RE: Application Number 20-6883; 1035 Clark: Hubbard Farms Historic District

NOTICE OF DENIAL

NOTICE TO PROCEED

EXISTING SILL AND JAMB

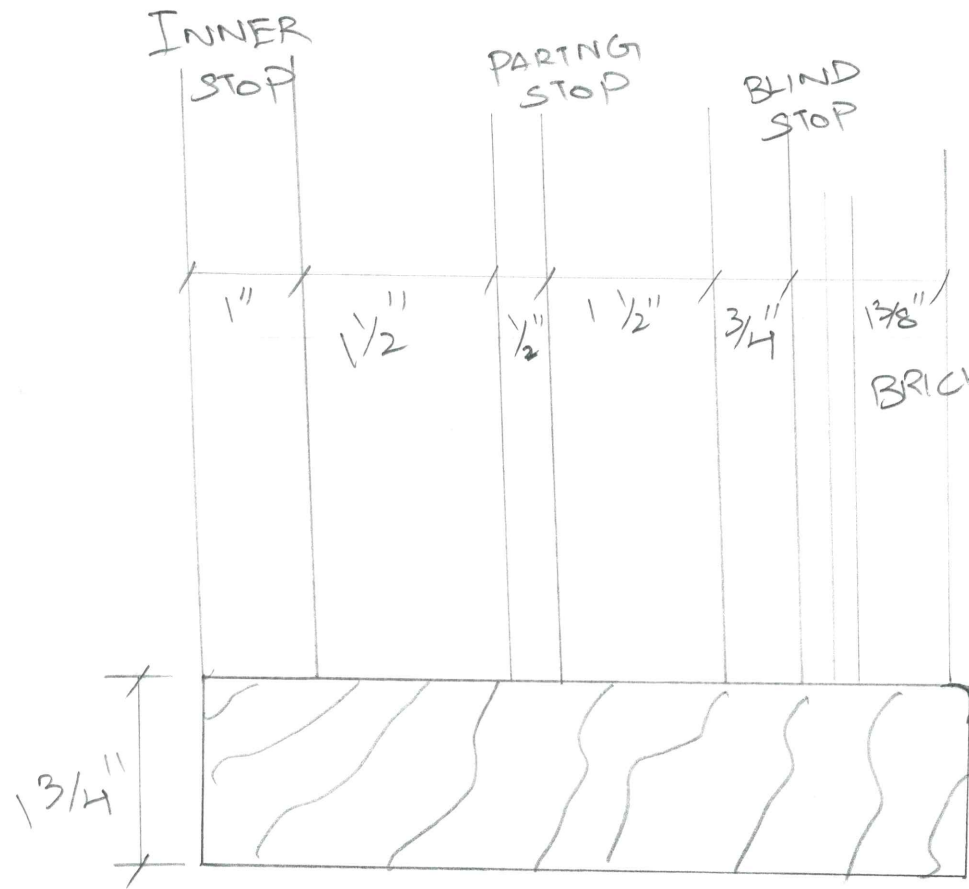
- The existing windows will remain in place until the replacement windows are approved by Commission staff.
- The new window frame dimensions shall not increase more than ¼-inch (from the existing wood frame dimensions).

- The existing casings, inner stop, and brick mould will be retained and will remain in their current condition.
- The leaded glass transom window will remain in place and be repaired as needed. A storm window may be installed to mitigate noise.

- The existing exterior wood brick mould will be retained and will remain covered with aluminum.

CASEMENT WINDOW - IOBS CLARK

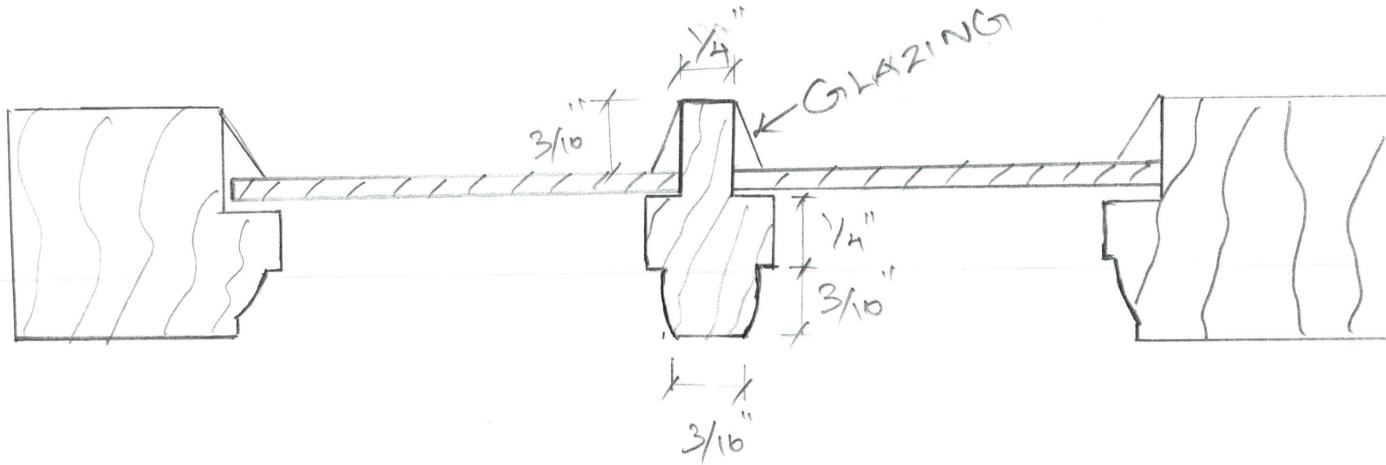
- Second floor, rear elevation, vinyl frame sliding window.
 - Third floor, rear elevation, two square casements (each with a two-over-two muntin pattern) and wood mullion

- Existing wood mullions, if present, will remain in place. New, single window units will be inserted into existing window openings.
- The casement windows will have a simulated divided light muntin pattern.
